**Thomsons Lake Urban Development and South
Jandakot Drainage Management Plan, deferral of
construction of the South Jandakot Branch Drain**

Proposed change to Environmental Conditions

**Report and recommendations
of the Environmental Protection Authority**

**Environmental Protection Authority
Perth, Western Australia
Bulletin 824
June 1996**

Figure 2. Hydrograph for Thomsons Lake (1988 - 1995). (Source: Water Authority, November 1995.)

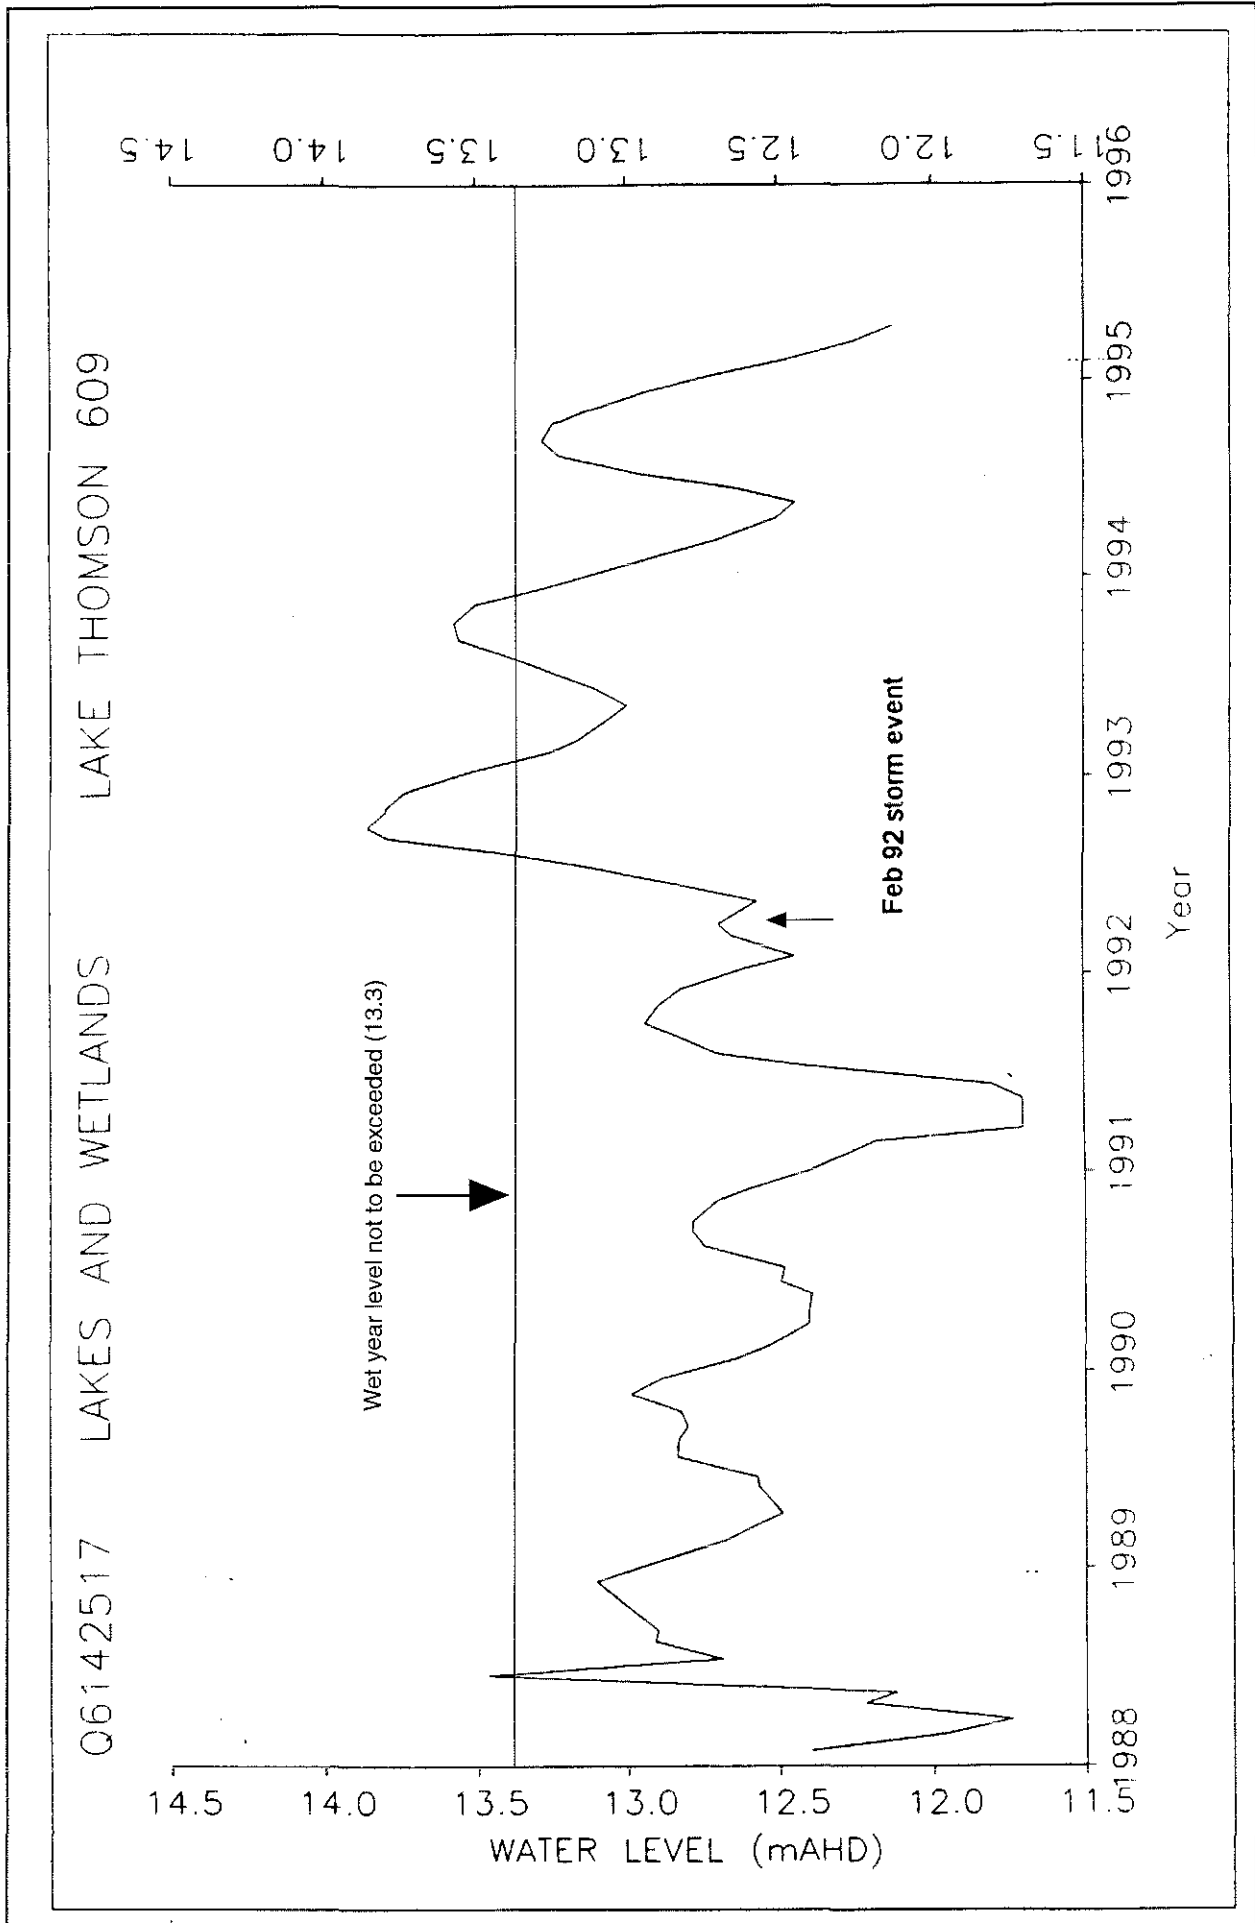
7. The earlier monitoring was more sporadic and it would be more correct if earlier points are not joined, but under the data system used to store these levels the plots are generated automatically in this format. The levels recorded are not in dispute however and it is quite valid to compare current levels with earlier levels. Although the drains have not been monitored there is historical evidence to show that the drain has been in operation for many decades.
